### Proposed Revisions to a Standard Plans Index

Index Number: 102-110

Sheet Number (s): 4 of 17

Type K Temporary Concrete Barrier System

SHEET  
4 of 17

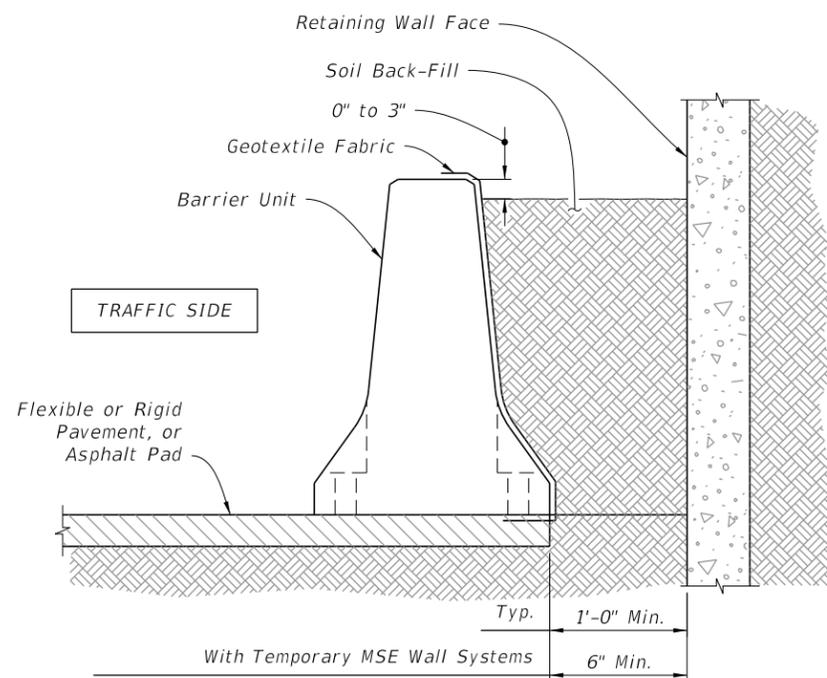
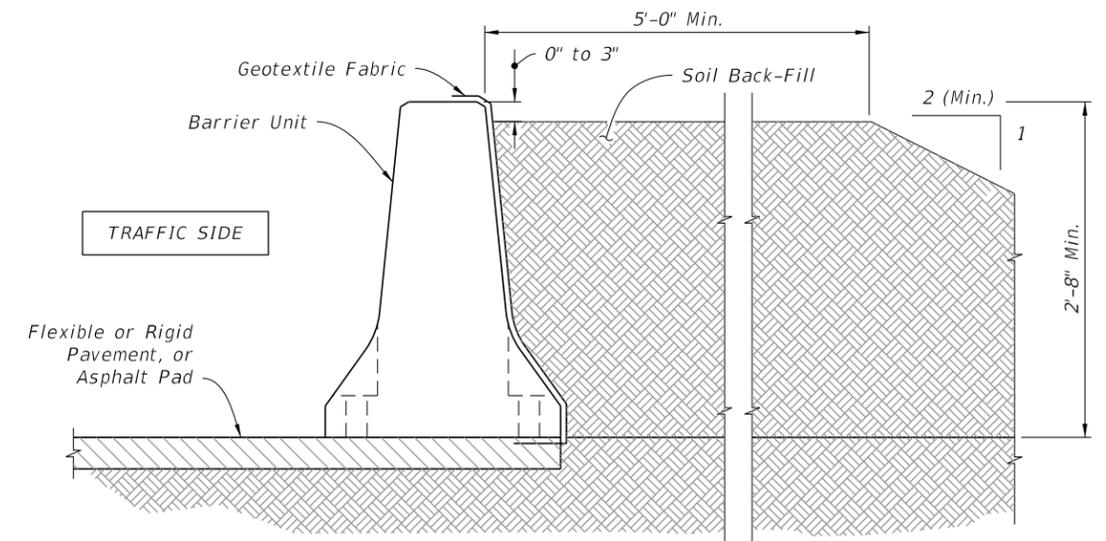
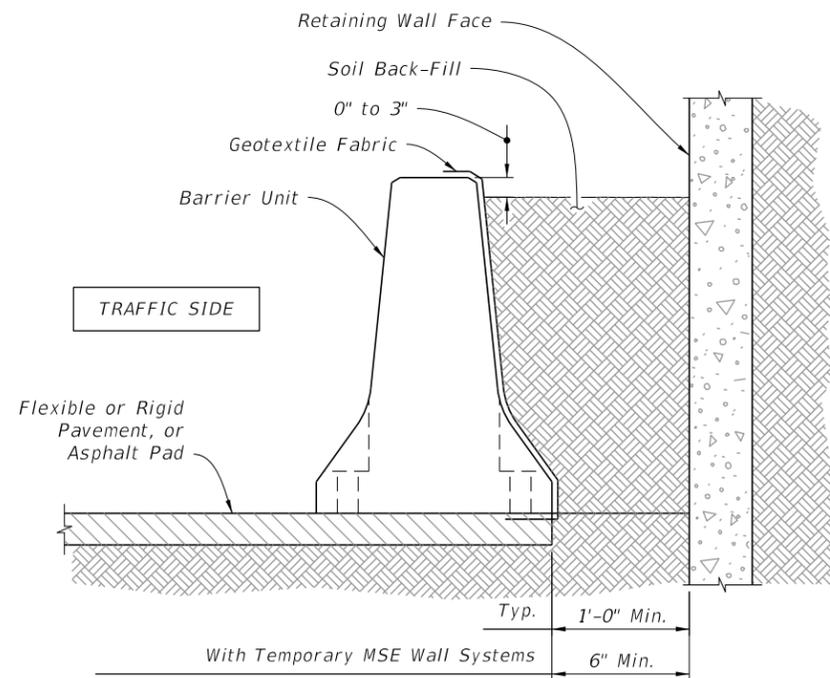
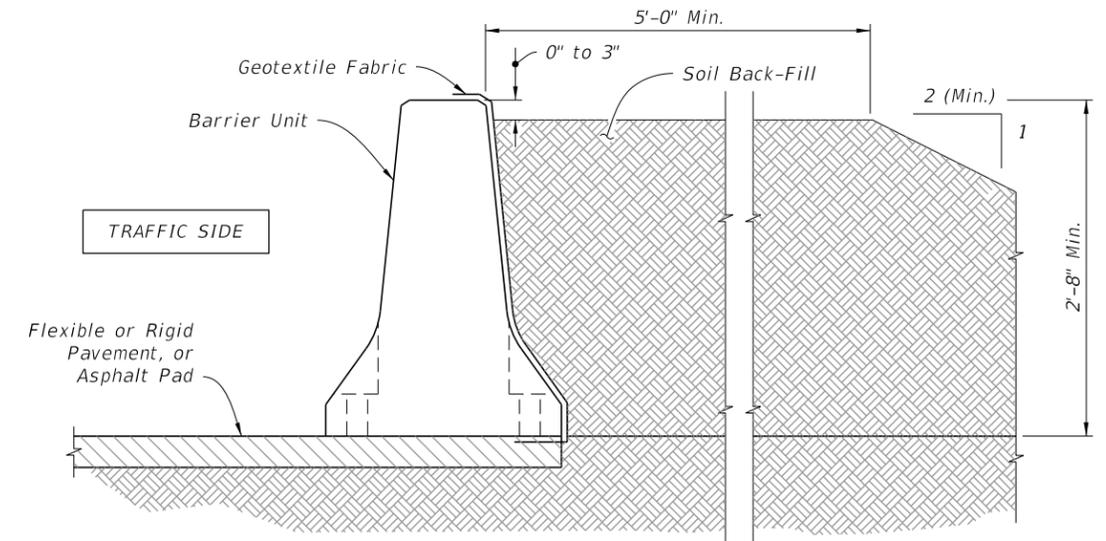
Sheet 4: Updated the GEOTEXTILE FABRIC Note: GEOTEXTILE "Provide and install Type D-5 geotextile fabric in accordance with Specifications 514 to contain Back-Fill Materials behind the Barrier Units."

**UPDATED:** Provide and install Type D-5 geotextile in accordance with Specifications 514 to contain Back-Fill Materials behind the Barrier Units.

**GEOTEXTILE FABRIC:** Provide Type D-5 Geotextile Fabric in accordance with Specification 985 to contain Back-Fill Material behind Barrier Units. Geotextile Fabric may be continuous over the length and height of the installation or may be individual pieces as required to cover the Lift/Drain Slots and open vertical joints between Barrier Units.

**GEOTEXTILE:** Provide and install Type D-5 geotextile in accordance with Specification 514 to contain Back-Fill Material behind the Barrier Units. Geotextile may be continuous over the length and height of the installation or may be individual pieces as required to cover the Lift/DrainSlots and open vertical joints between Barrier Units.
